SERVICE BULLETIN

SB-8-628-001

ATTENTION: SERVICE MANAGERS / PARTS MANAGERS
SUBJECT: CHANGING POSITION OF WIPER ARMS

Figure 4

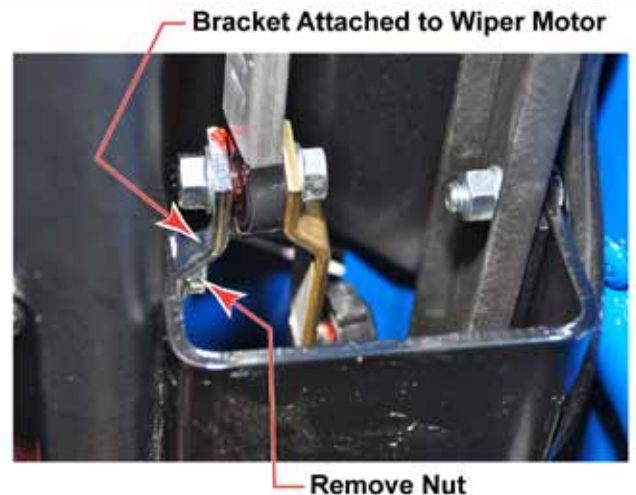
4. Remove the nut from the bracket that is attached to the wiper motor (see *Figure 4*).

Figure 5

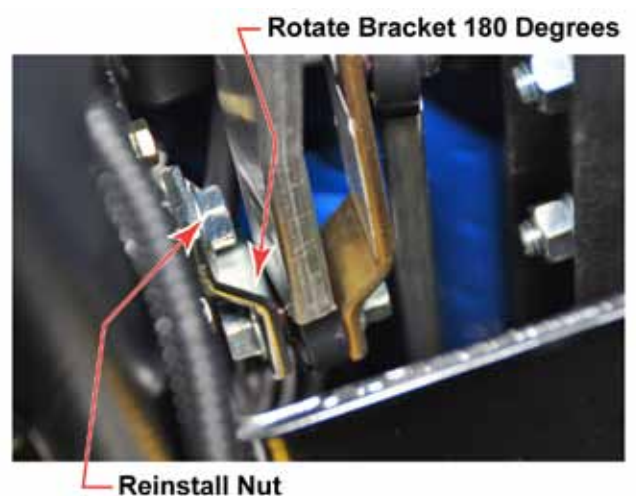
5. Rotate the bracket 180 degrees from the original position (see *Figure 5*) and reinstall the nut.
